# Product Change Notification (PCN)

PCN Number	502735	Date Issued	May 02, 2017
Reason for Change	Capacity change or tool replacement		
Change Type Description	This letter is to inform you that another set of tooling is being added to meet the current and future demands of this product. There will be no changes in the fit, form or function from the additional tooling when compared to the current tooling.		
Reason for Short Notice	New Capacity		
Assessment of Change	Product will be fully qualified before it is shipped. Qualification reports are available upon request.		
Internal Molex Qualification Date	June 20, 2017		
Sample Availability Date (Changed Part)	June 20, 2017		
Planned Implementation Date	June 20, 2017		
Method of Identifying Change	Product made after planned implementation date can contain the change

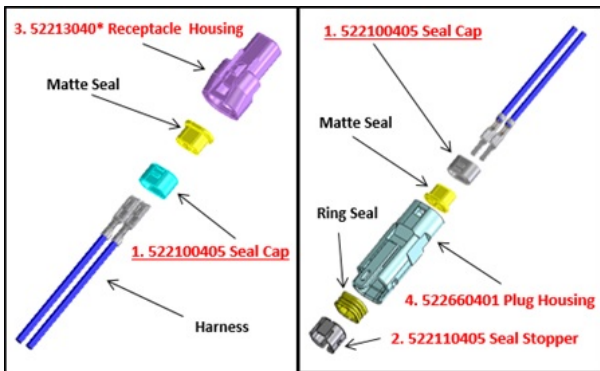
Molex will replace current aging molding dies by new ones at a new supplier for the 1, 2, 3, 4 components shown on the image. The manufacturing sites of Finished Goods do not change before or after the replacement.

There will be no negative influences on Product's Fit, Form, Function, or Appearance. Mass production date with use of new tools is scheduled around 2017/6/20.
